# UNITED STATES PATENT AND TRADEMARK OFFICE

APPLICATION NO.	FILING DATE	FIRST NAMED INVENTOR	ATTORNEY DOCKET NO.	CONFIRMATION NO.
09/627,637	07/28/2000	Kenichi Oinoue	P/3541-6	2855

## Office Action Summary

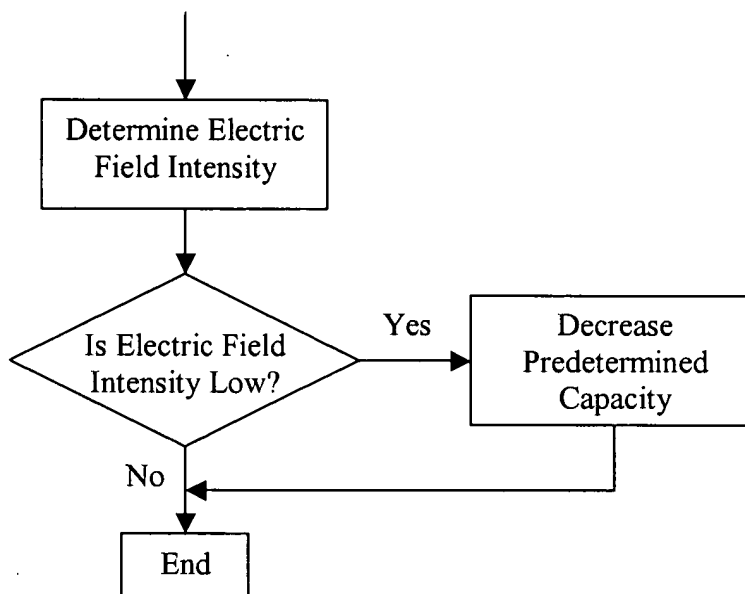
Should Applicant adopt Examiner’s suggestions with regards to the claims, the Examiner further suggests that the Applicant add a further figure so as to show the limitations above. The Examiner suggests submitting a flow chart similar to the one illustrated bellow.

In order to overcome this rejection the Examiner suggests amending claim 9 to read “said transmission control means includes judgment means to judge the capability of transmitting the recorded information to a nearest communication base station, and said setting means decreases the set memory capacity when said judgment means judges that there is a low capability to transmit the recorded information.” Examiner suggests similar amendments to claims 10 and 17-20.
